16 August 2021

RE : RESPONSE TO APPEAL AGAINST THE DECISION TO REFUSE THE APPLICATION FOR ENVIRONMENTAL AUTHORISATION 14/12/16/3/3/2/2006 APPLIED FOR BY KARPOWERSHIP SA (PTY) LIMITED FOR THE GAS TO POWER VIA POWERSHIP PROJECT AT THE PORT OF SALDANHA WITHIN THE SALDANHA BAY LOCAL MUNICIPALITY, WESTERN CAPE PROVINCE

156. **Aquaculture Development Zone**

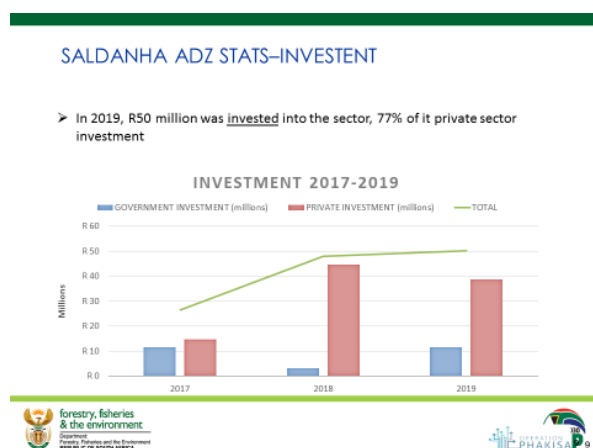
The potential economic negative impact on the Aquaculture development does not seem to have been assessed. In the aquaculture sector, 663 people are directly employed, with 570 (86%) permanent.⁹⁰ Karpower does not provide any indication if women will be employed but 55% of employees in aquaculture are women. Karpower has a category of construction jobs which indicate that 98 skilled black employees and that category could include women. There are no guarantees. In direct comparison, Karpower claims it will employ 133 local citizens whereas the AQZ already employs 663 people.
